UNITED STATES PATENT AND TRADEMARK OFFICE

Office Action Summary	Application No. 10/642,343	Applicant(s) GIESSLER ET AL.	
	Examiner Sara Addisu	Art Unit 3722

DETAILED ACTION

This Office Action is in response to the amendment filed 3/29/06. Currently, claims 1-10 are pending in this application.

FIG. 5B

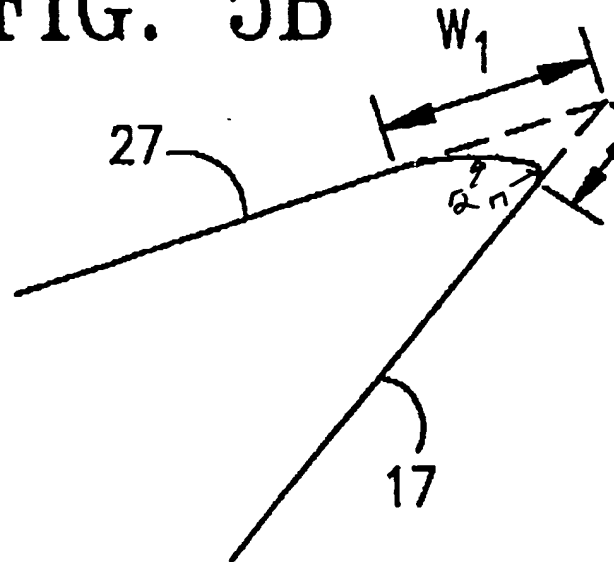
However, BRITZKE ET AL. fails to teach the milling cutter being an end mill having main cutting edges extending along an edge of the cutting grooves as well as being arranged substantially in a common plane.

Sato et al. teaches an end mill having a shank (12) and a cutting part having cutting edges extending along an edge of the cutting grooves and being arranged substantially in a common plane ('409, figure 1 and page 1, paragraph 2).

Therefore, it would have been obvious to one of ordinary skill in the art at the time of the invention was made to include cutting edges that extending along an edge of the cutting grooves (and arranged substantially in a common plane) of BRITZKE ET AL's invention, as taught by Sato et al., for the purpose of using the tool in slot or shoulder milling operations ('490, page 1, paragraph 2, lines 6-7) since BRITZKE ET AL. teaches the invention can be used on other tools such as milling cutters ('447, Col. 5, lines 53-59).
